Access Compliance Report

Public Rights-of-Way

(Curb Ramps)

Intersection ID: 18701	Main Street: PROVIDENCE_RD	Cross Street: RUTLEDGE_AV	Location: NE
ADA ID: E7D62C56D64B	Ramp Type: PerpDiag	Initial Pass/Fail: Fail	Overall Compliance: No
Codes/Mitigation Info/Possible Solution		Field Measurements/Component Compliance	
Severity Score: 33.75

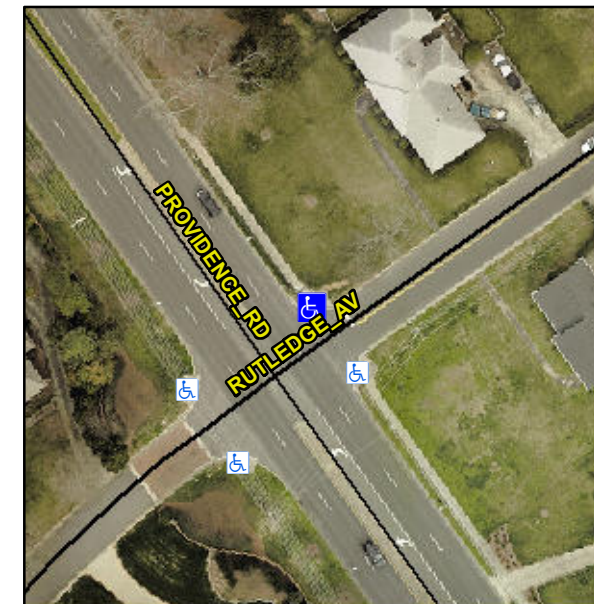
Not Found, R304.5.1, R304.2.2, R304.5.3

Compliance	Description	Data	Compliance	Description	Data
N/A	Ramp Length (in)	48.0	No	Ramp Slope (%)	9.5
No	Ramp Width (in)	39.0	No	Ramp XSlope (%)	5.5
N/A	Flare Type LT	N/A	N/A	Flare Type RT	N/A
N/A	Flare Slope LT (%)	N/A	N/A	Flare Slope RT (%)	N/A
N/A	Flare Traversable LT?	N/A	N/A	Flare Traversable RT?	N/A
N/A	Landing Length (in)	N/A	N/A	DWS Provided?	N/A
N/A	Landing Width (in)	N/A	N/A	DWS Contrast?	N/A
N/A	Landing Slope (%)	N/A	N/A	DWS Length (in)	N/A
N/A	Landing X Slope (%)	N/A	N/A	DWS Full Width?	N/A
N/A	Landing Curb? (Y/N)	N/A	N/A	DWS Offset (in)	N/A
N/A	Shared Landing?	N/A			
N/A	Gutter Ponding?	N/A	N/A	Gutter Slope (%)	N/A
N/A	Gutter Lip Ht (in)	N/A	N/A	Gutter X Slope (%)	N/A
N/A	Painted X Walk1?	No	N/A	Painted X Walk2?	No
	X Walk 1 Direction	To SW		X Walk 2 Direction	To SE
N/A	X Walk 1 Width (in)	N/A	N/A	X Walk 2 Width (in)	N/A
	X Walk 1 Slope (%)	10.1		X Walk 2 Slope (%)	1.0
	X Walk 1 X Slope (%)	2.9		X Walk 2 X Slope (%)	5.3

N/A	Ramp inside XWalk1?	N/A	N/A	Ramp inside XWalk2?	N/A
	Road Slope (%)	4.9	N/A	Clear Space?	N/A
	Road X Slope (%)	8.8	N/A	Clear Space to XWalk (in)	N/A
N/A	Any Obstructions?	N/A	N/A	Storm Grate/Utility Hazard?	N/A
	Obstruction Type			Storm Grate/Utility Type	
		N/A			N/A
			Yes	Surface Condition? (G/P)	Good

Remove & Replace Curb Ramp With Two New Directional Ramps or Equivalent.
